Addendum #1

RE: REQUEST FOR TENDER #2024-137-P01947
Hess Street Elementary School – Renovation Project

Addendum No. 1

PROJECT:	HWDSB Hess Elementary School	DATE:	April 24 th , 2024
PROJECT #:	23035	FROM:	Binayak Raj Maurya
TO:	NGA Architects	ATTENTION:	Ivana Paukovic

- NEW DRAWING NOTES:**
- 1** CAP AND MAKE AIRTIGHT ALL UNUSED BRANCH CONNECTIONS AT SUPPLY DUCTS. (TYP.)
 - 2** PROVIDE NEW EXHAUST AND SUPPLY GRILLES AND DUCTWORK AT THE SPECIFIED LOCATIONS.
 - 3** EXISTING DUCT BRANCH TO BE RE-BALANCED.

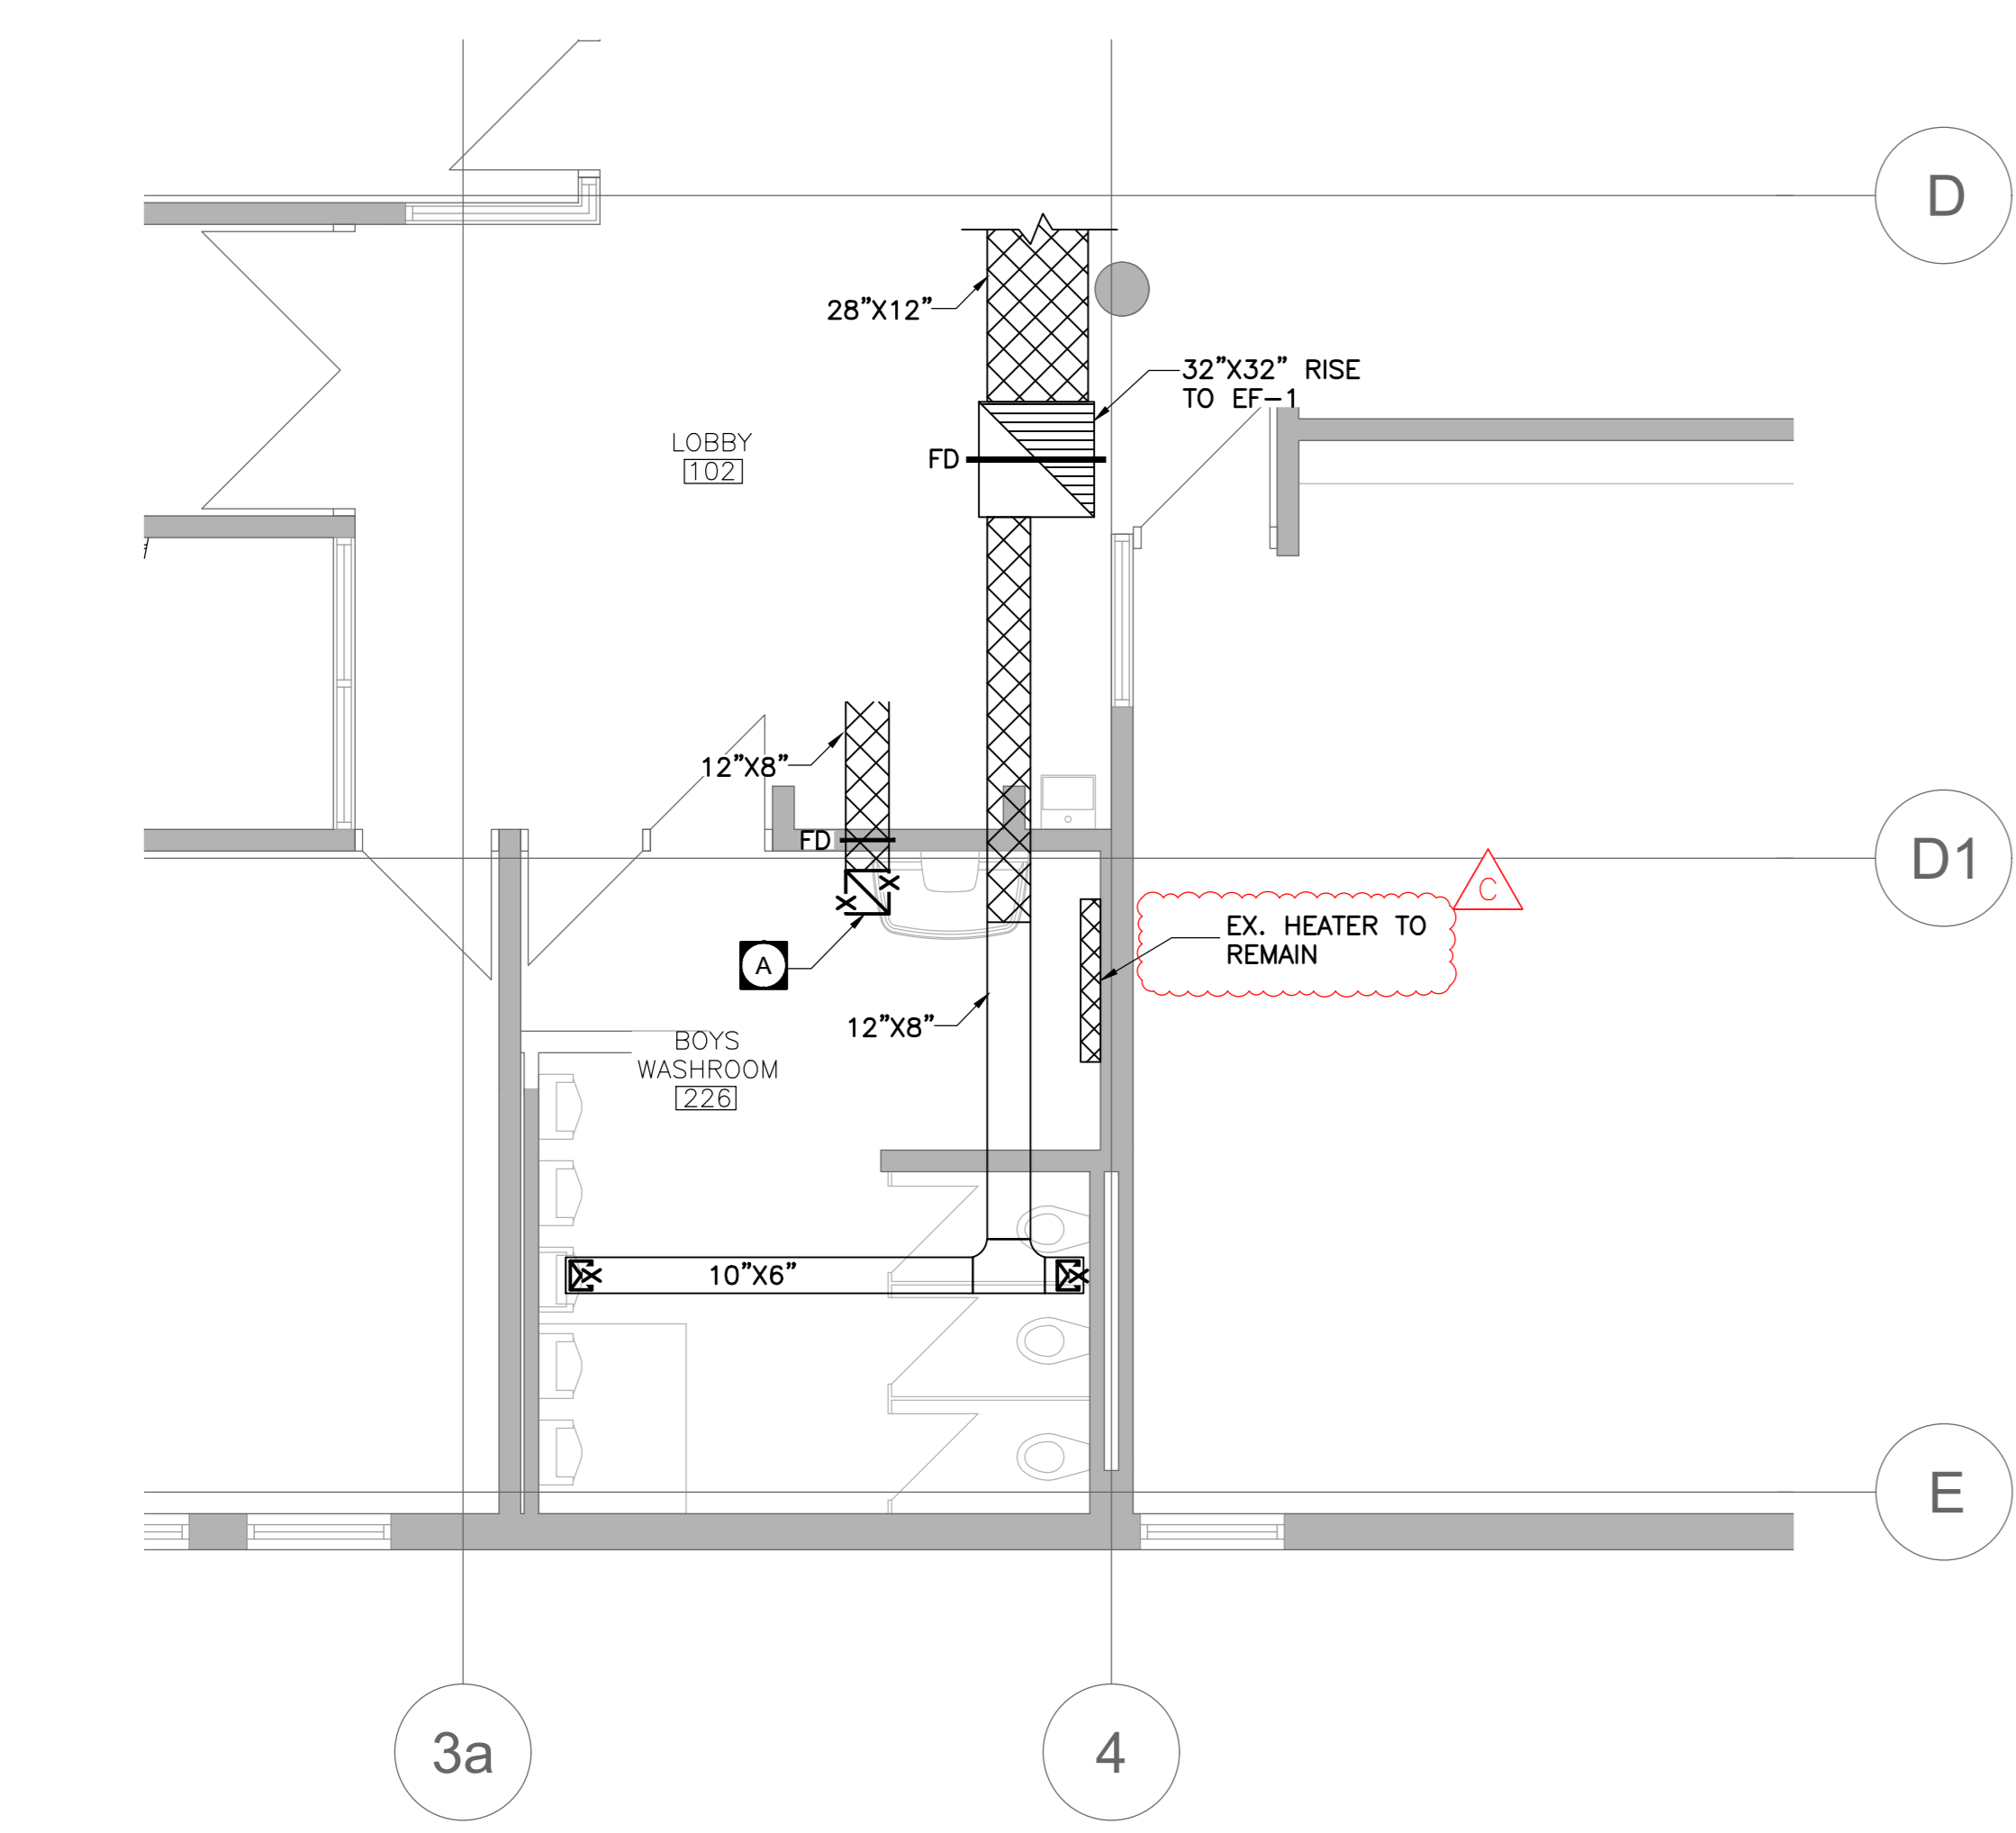
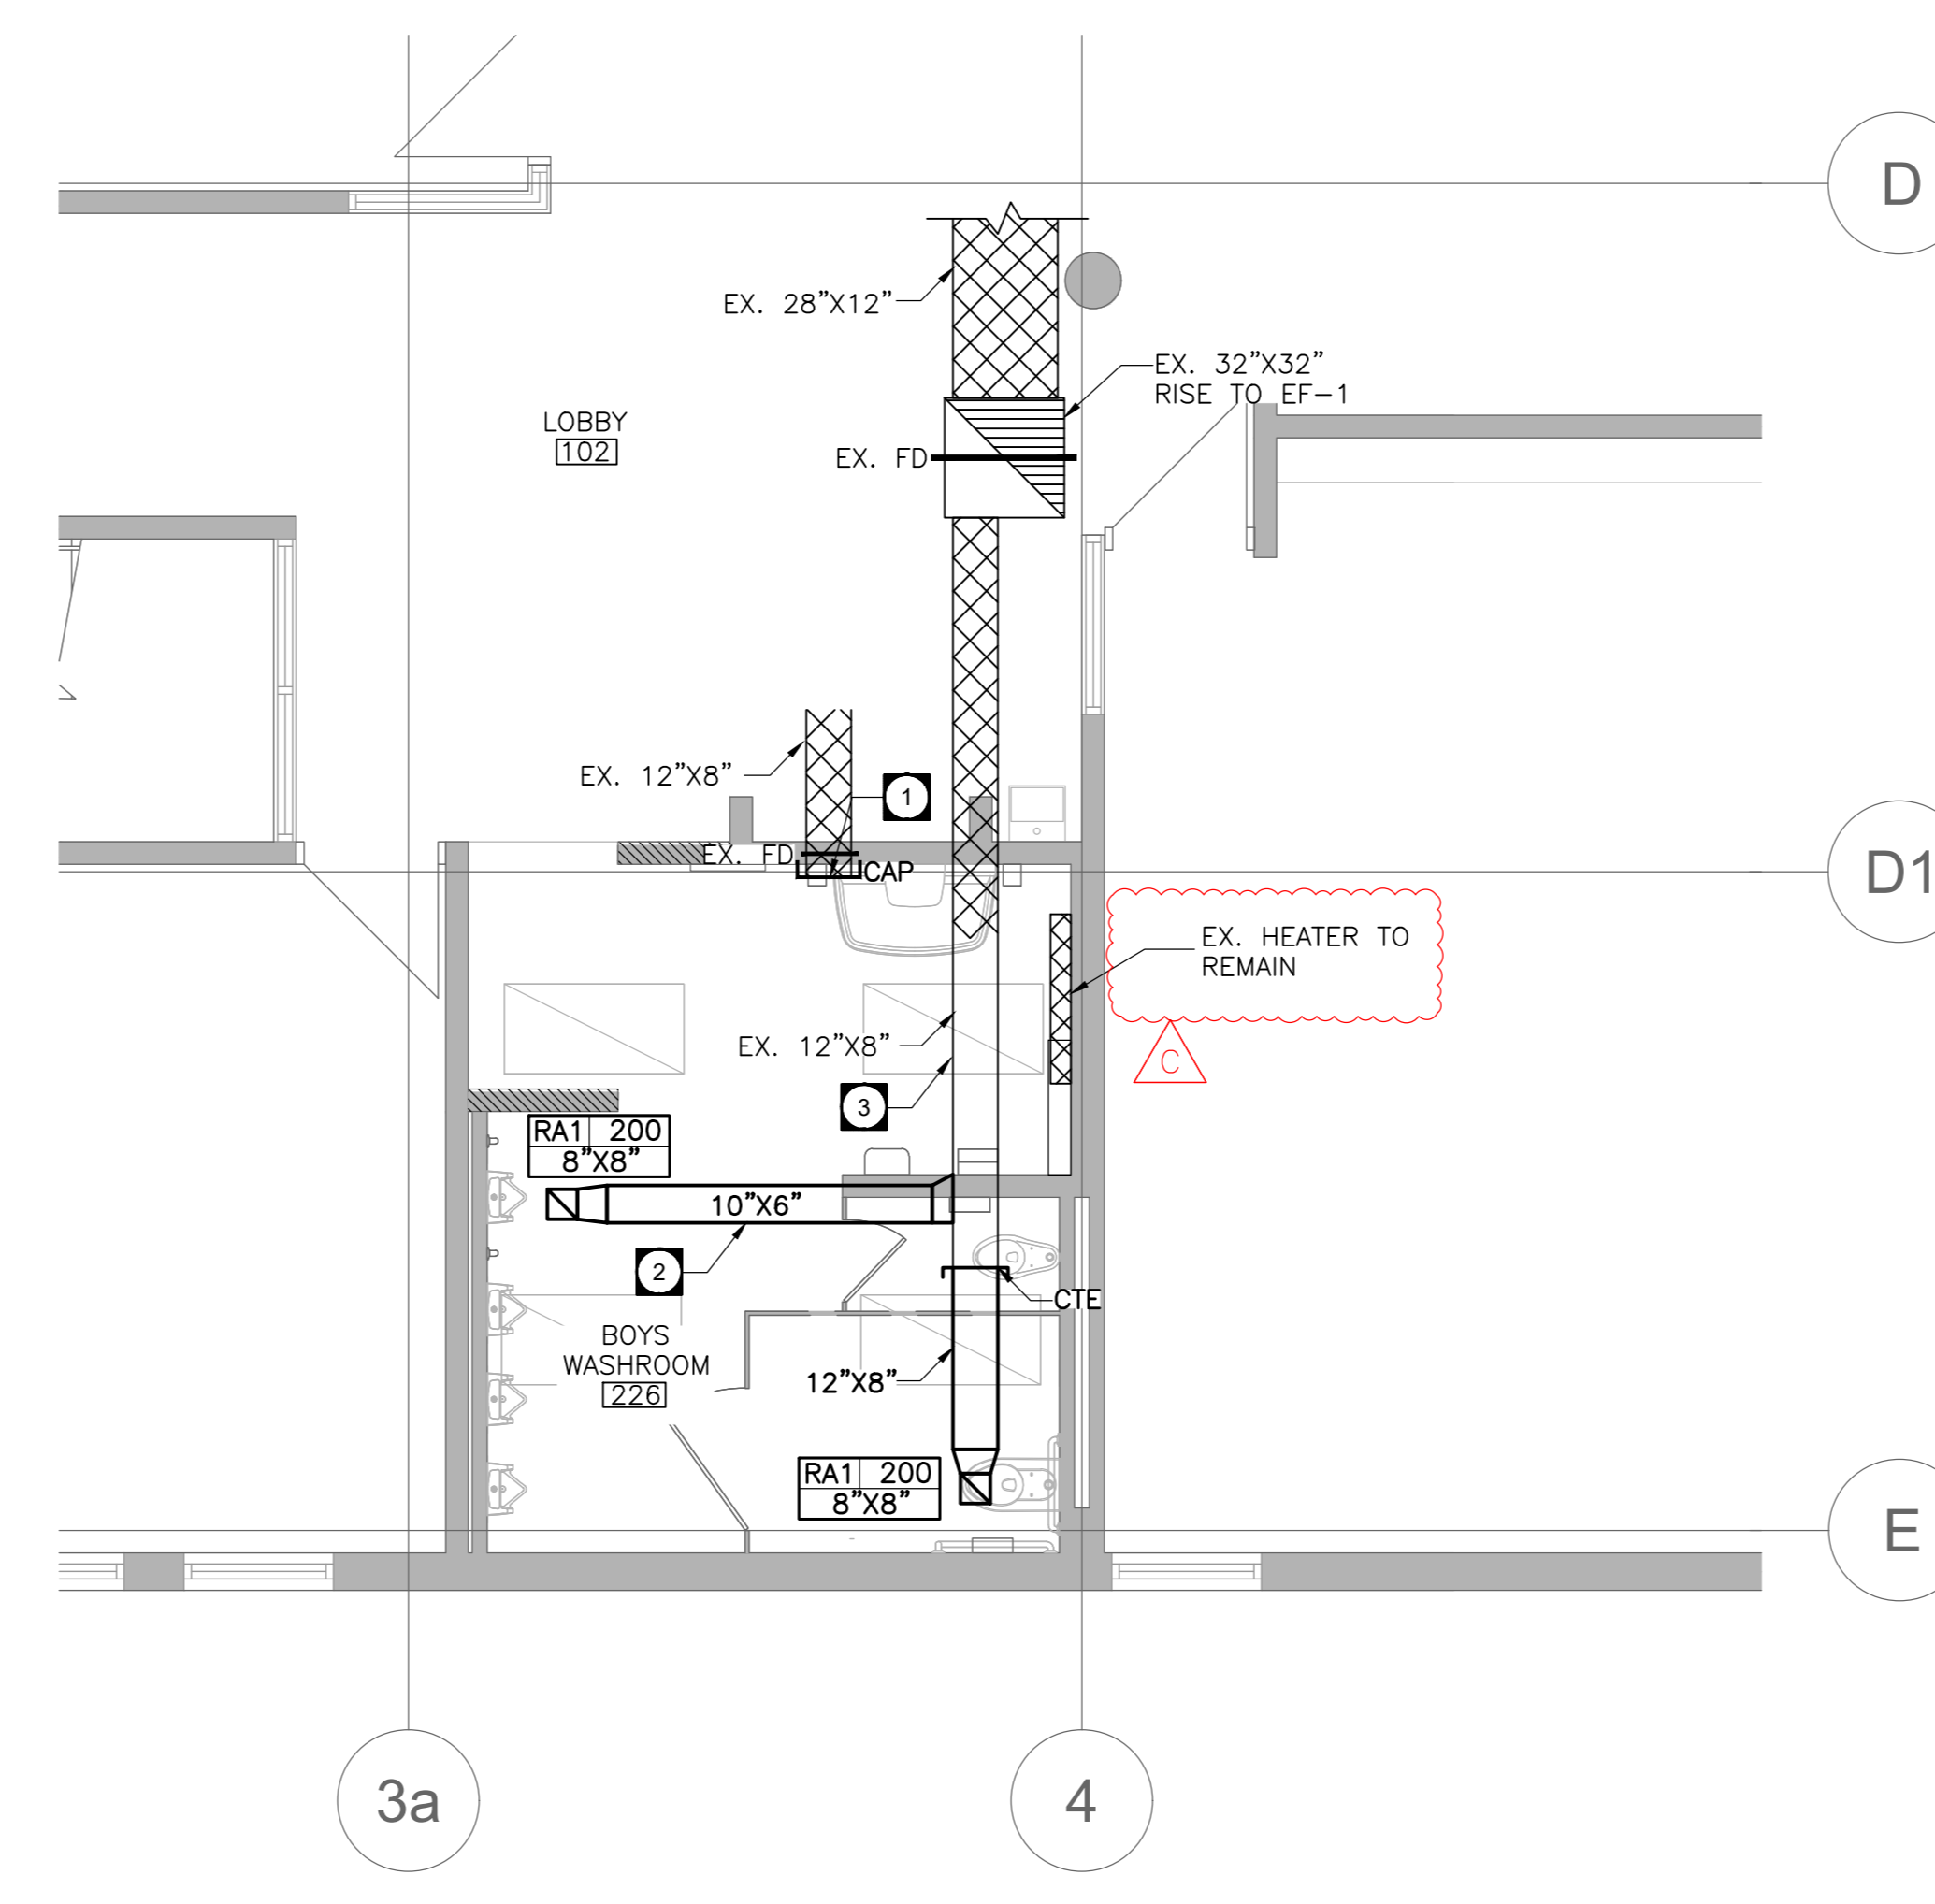
- 2) **Question:** On drawing M1.02, second floor girls w/r new duct layout, there is reference to a note 4. There isn't a note 4 under the new drawing notes.

1.3 Refer to Mechanical Drawing M 1.02 Rev. C

- “EX. HEATER TO REMAIN” tag has been shown at the locations of existing wall fin heaters in second floor Girls’ WR and Boys’ WR.
- Note numbers have been updated in the second floor Girls’ WR New HVAC Layout.

Answer: Revised note for new exhaust grille. Refer to attached Addendum No. 1 by CK Engineering Inc dated April 24, 2024.
